# ADDENDUM

Date Issued:	July 28, 2025
Project:	Intermountain Health Alta View Hospital – IR Rad Room #2 Remodel 9660 South 1300 East Sandy, Utah 84094
Addendum Number:	1

## IR Rad Room #2 Remodel

NJRA Project # 24239.00  
Construction Documents June 4, 2025  
I Addendum I July 28, 2025

A121

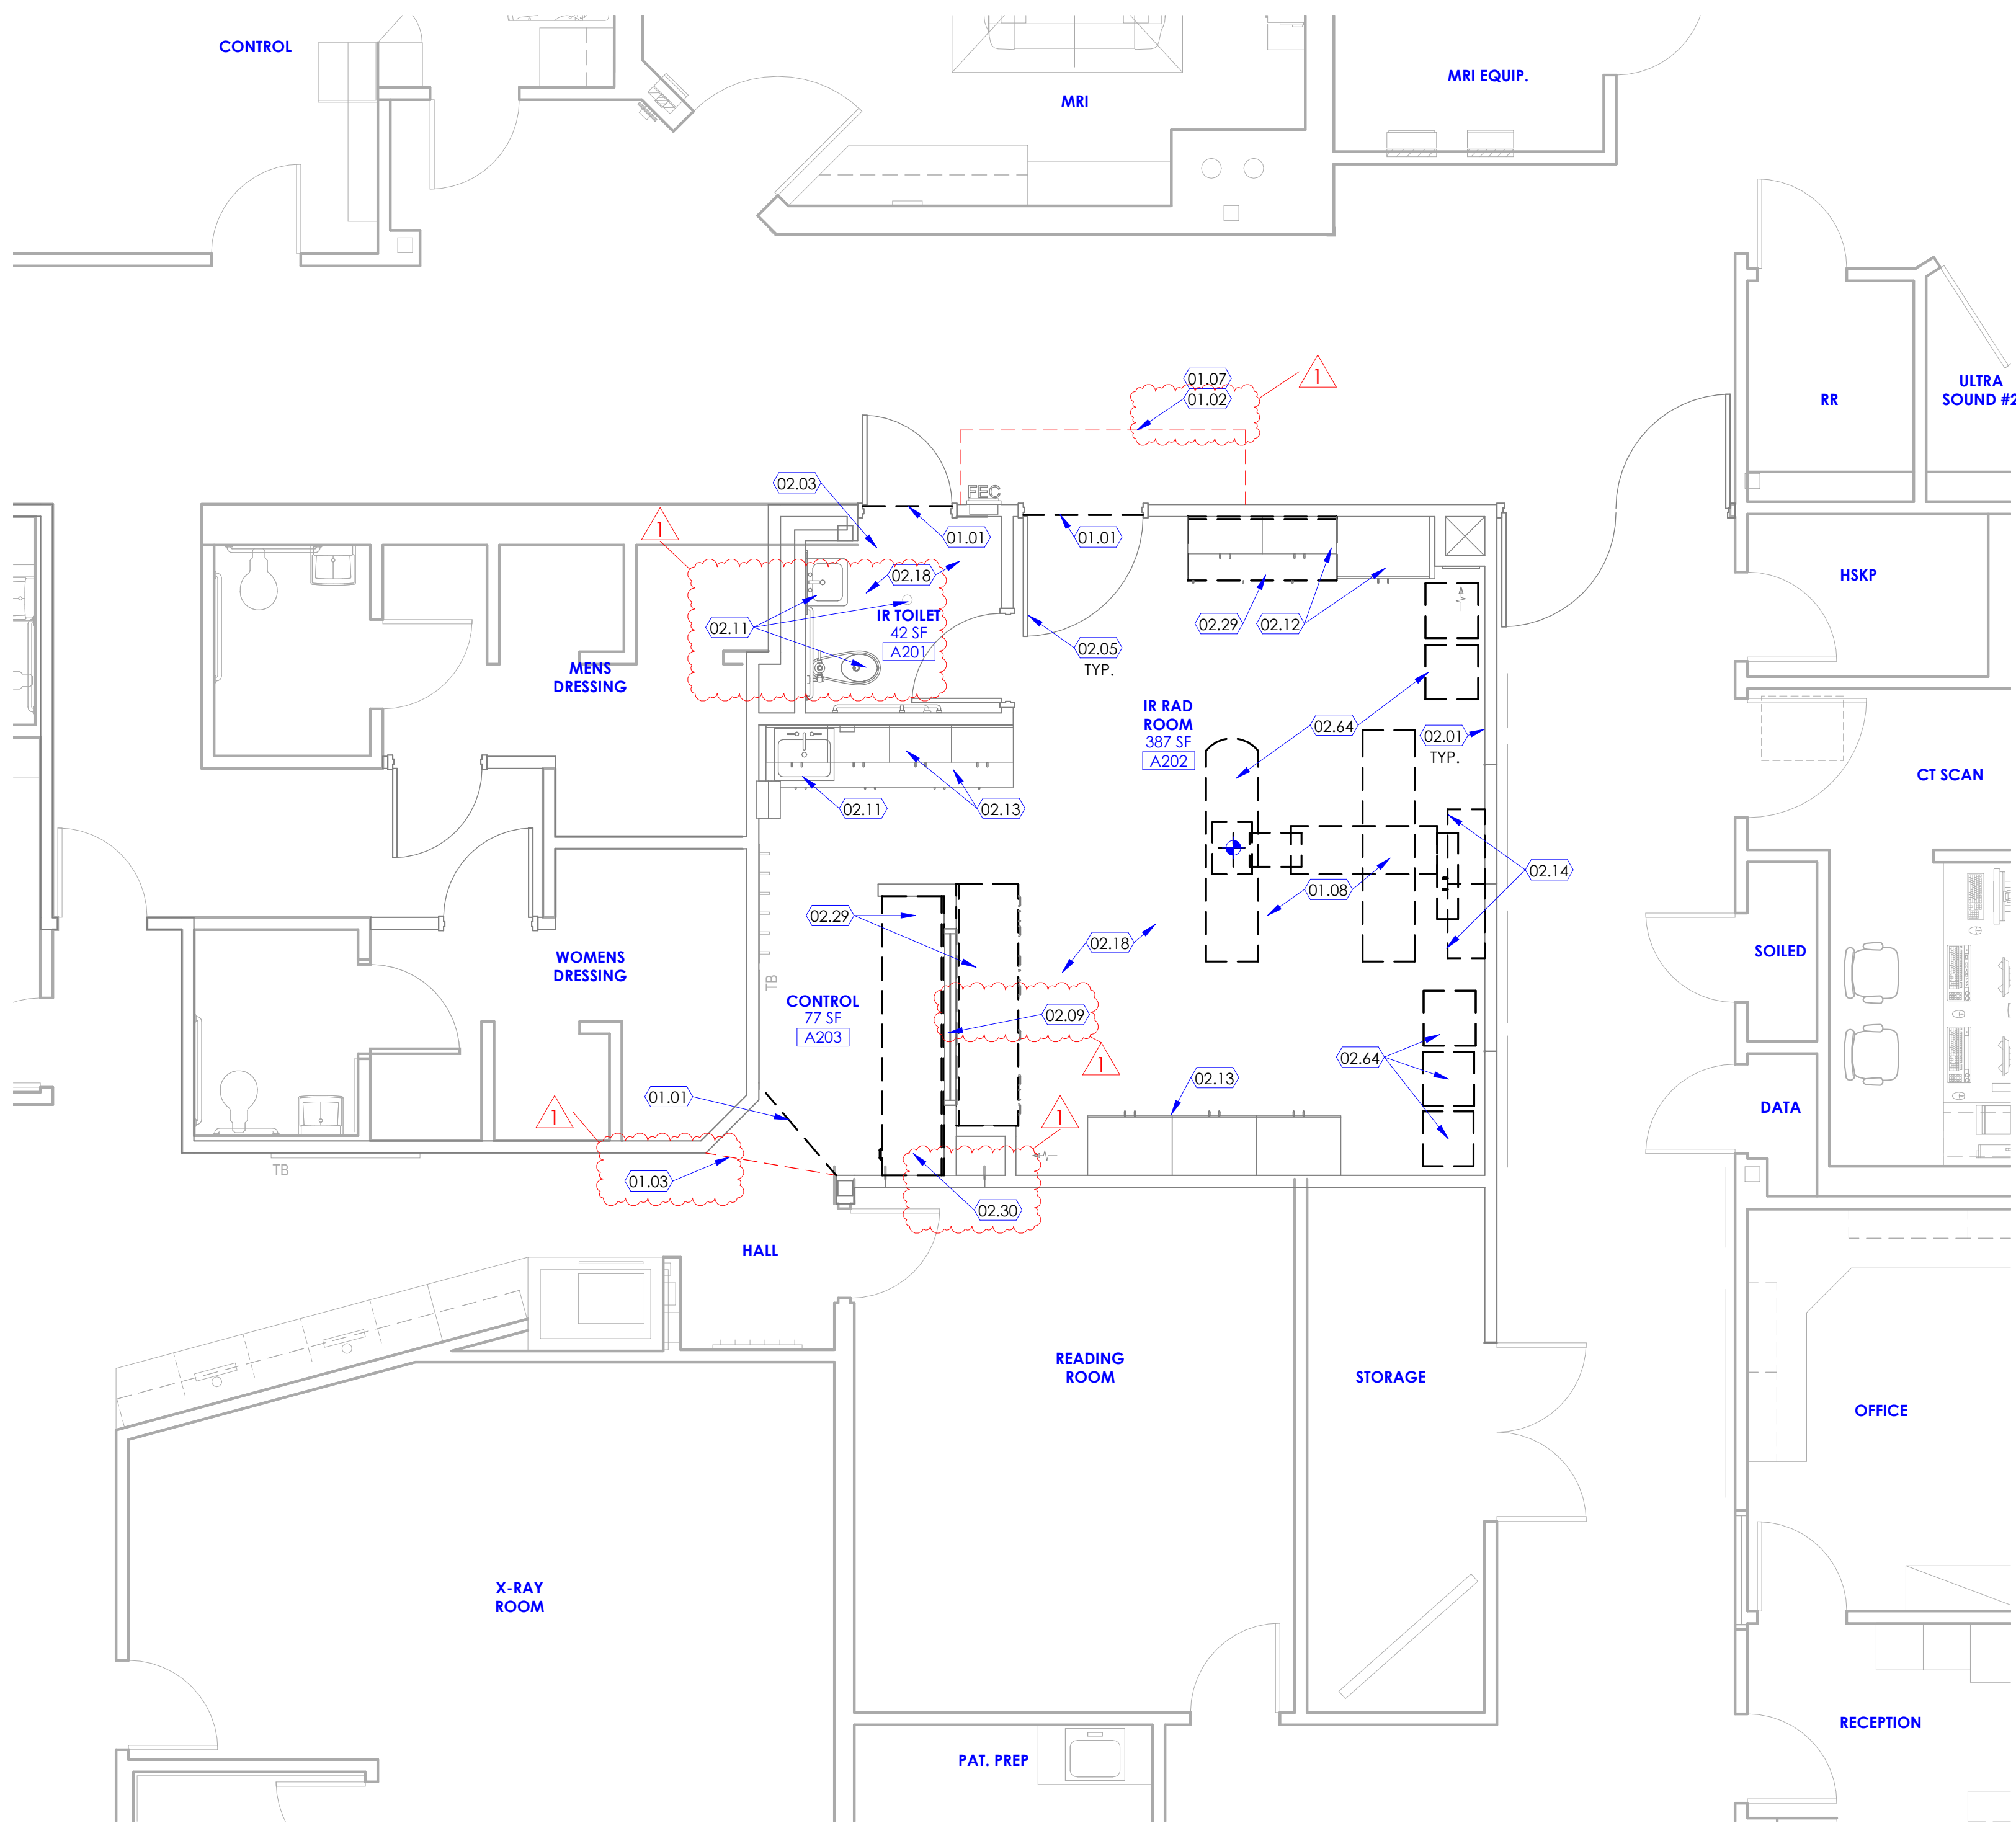
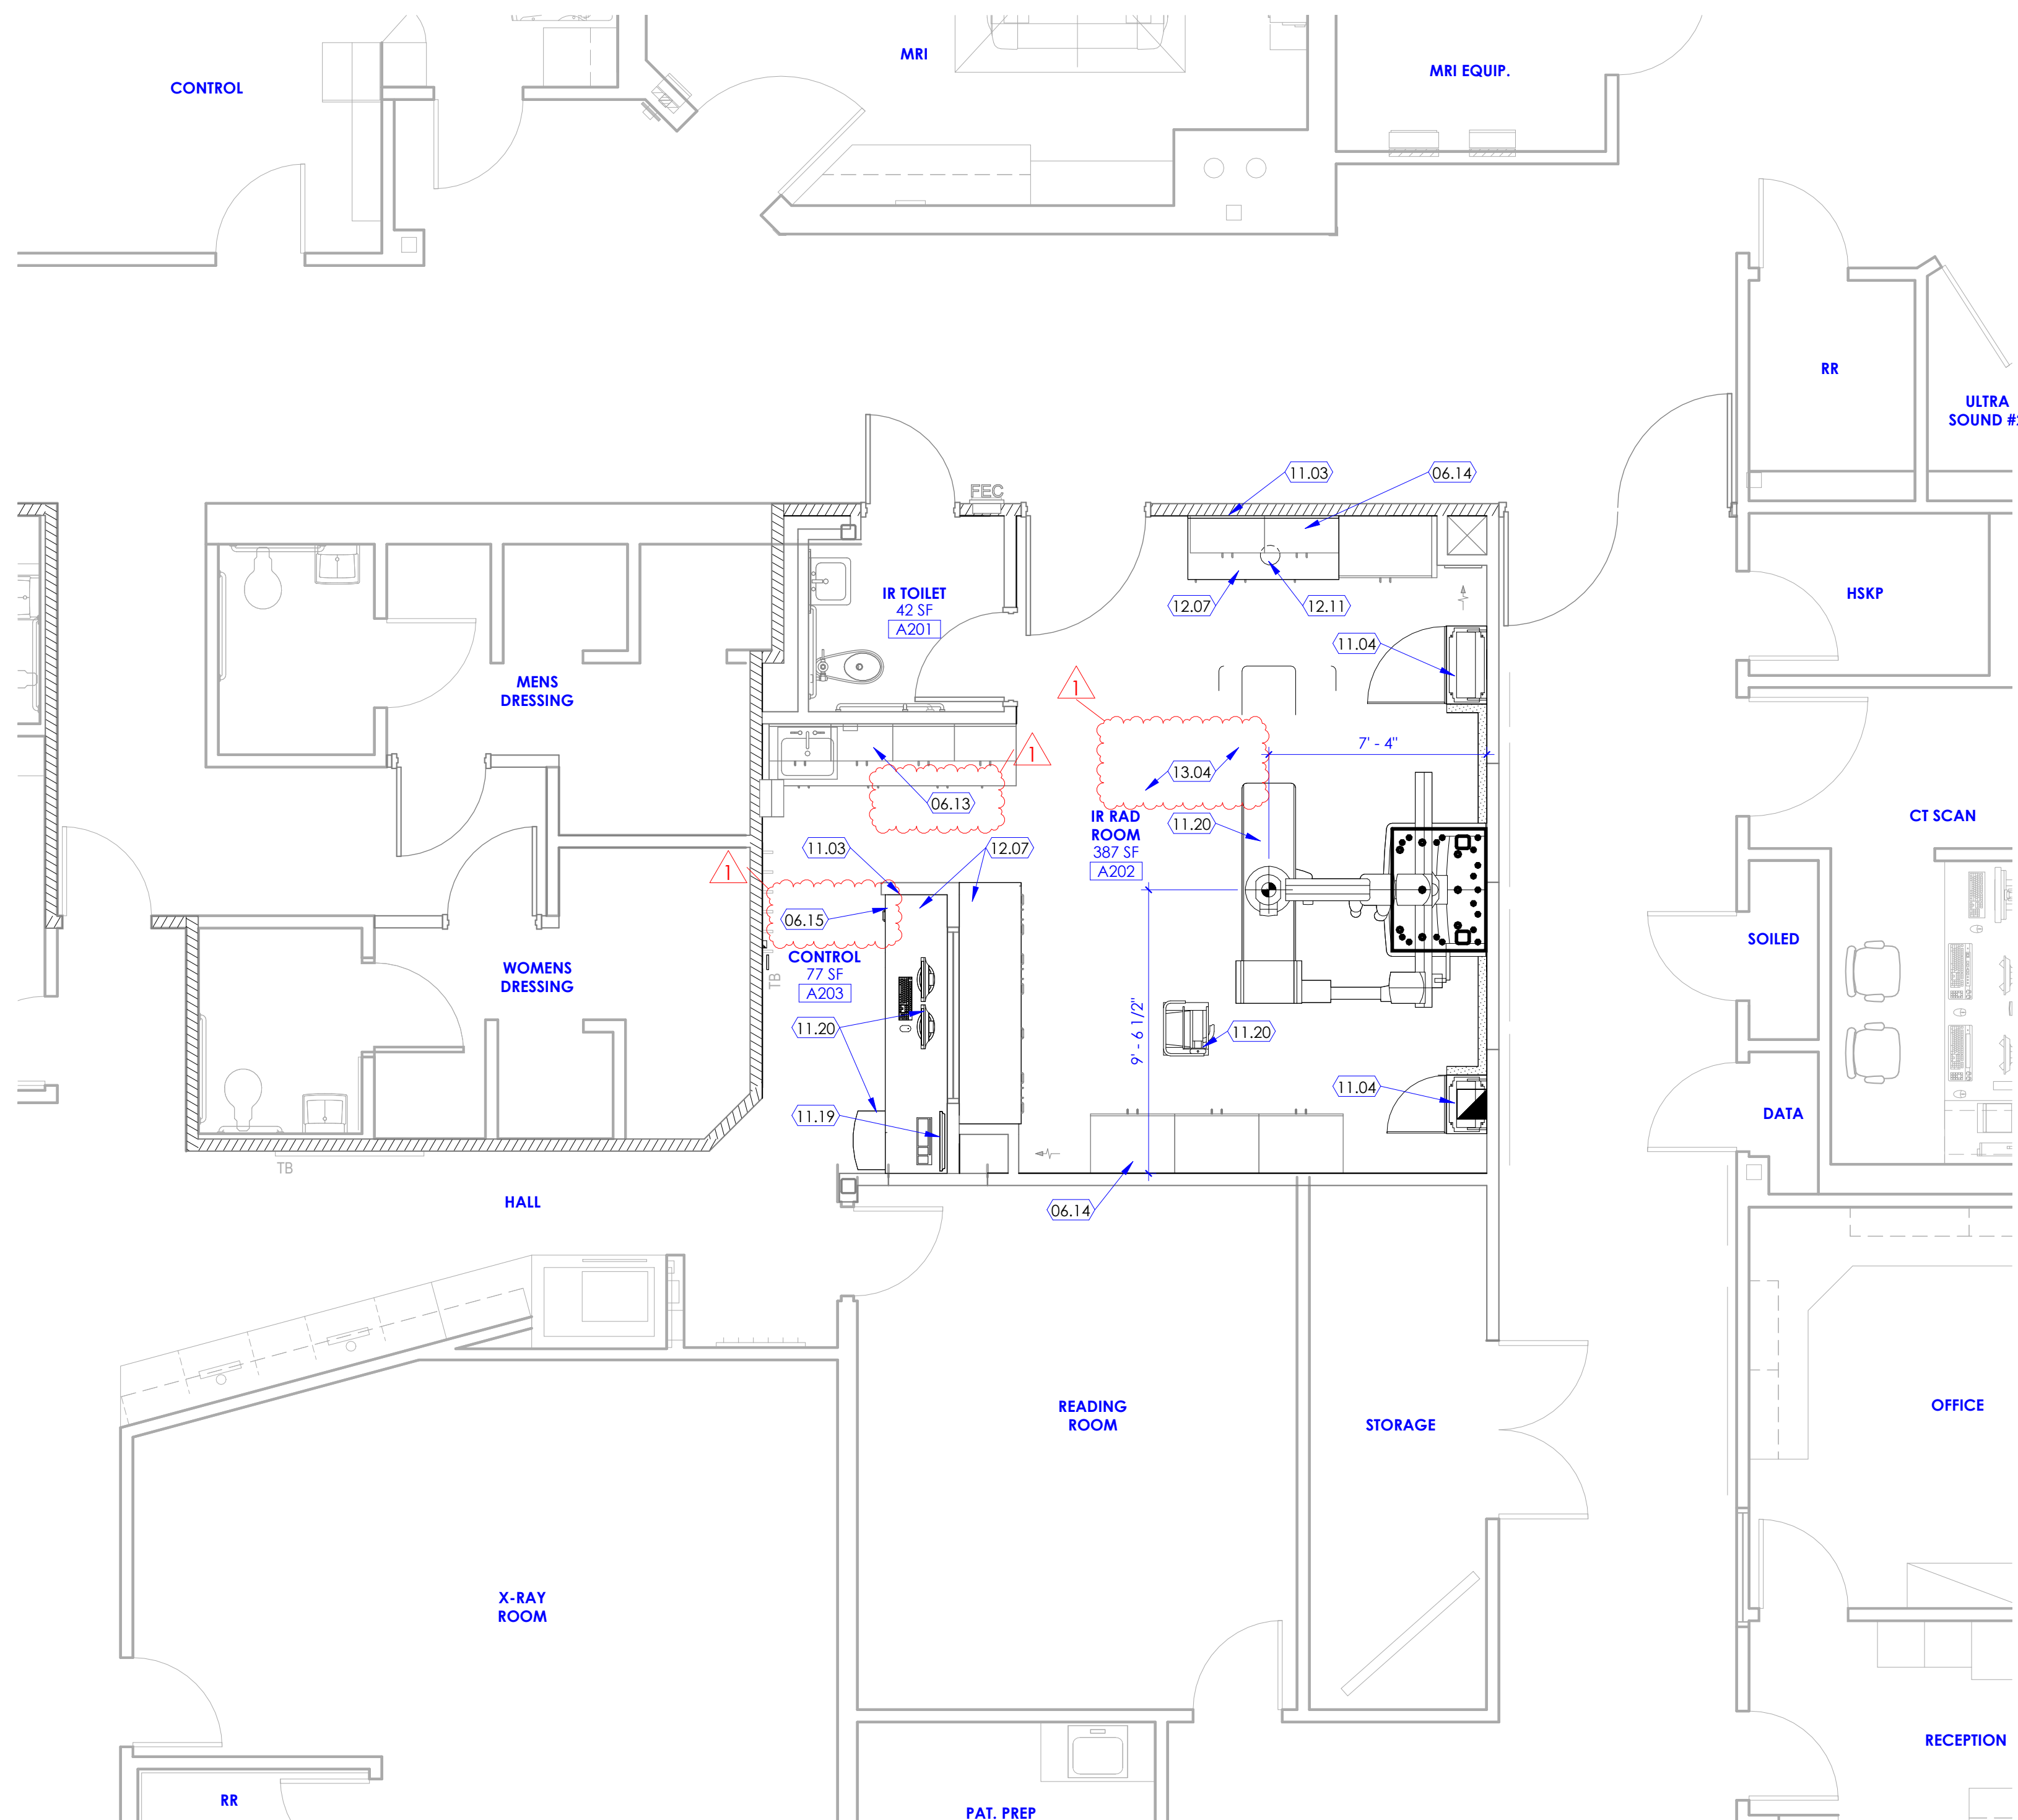
Sheet Number	Drawings
<b>Architectural Drawings</b>	
G001	Revised equipment note to reference Siemens for manufacturer equipment drawings.
A113	Revised keynote 01.02 to give preference for prefabricated construction barriers at solid wall barrier locations Revised keynote 01.03 To clarify visqueen sheeting type construction barrier requirements. Add keynote 08.01 to clarify new door and frame. Revise keynote 11.01 to coordinate with electrical one-line diagram. Add keynote 23.02 to include backing requirements for inline fan.
A121	Revised keynotes 01.02 and 01.03 per previous comment. Add keynote 02.09 to protect the existing lead lined shielding window. Add keynote 02.11 to clarify plumbing fixtures to be protected from damage/debris during construction. Revise keynote 02.30 to clarify cabinet to be relocated. Add keynote 06.13 for location to provide vertical casework fascia. Revise keynote 06.15 to provide fascia for exposed side of relocated base cabinet. Revise keynote 13.04 for lead shielded wall patching.

PROVIDE NEW VERTICAL FASCIA PER DETAIL 2/A505B AT LOCATION OF EXISTING CABINET. FIELD VERIFY AND MATCH EXISTING CABINET DEPTH.
- 06.14

REINSTALL EXISTING CONTROL ROOM BASE CABINET IN NEW LOCATION. SEE SIMILAR ATTACHMENT DETAILS ON SHEET A505B. PROVIDE NEW FASCIA FOR EXPOSED FACE AFTER RELOCATION.
- 11.03

EXISTING WALLS ARE LEAD SHIELDED THAT MEET OR EXCEED SHIELDING REQUIREMENTS NOTED IN THE PHYSICIST REPORT IN THE PROJECT MANUAL. ANY WORK IN THE WALLS THAT REQUIRES THE CONTRACTOR TO PATCH AND REPAIR THE WALL SHIELDING SHALL MAINTAIN THE EXISTING SHIELDING REQUIREMENTS. COORDINATE WITH THE OWNER TO SCHEDULE SHIELDING INSPECTION DURING AND AFTER CONSTRUCTION.
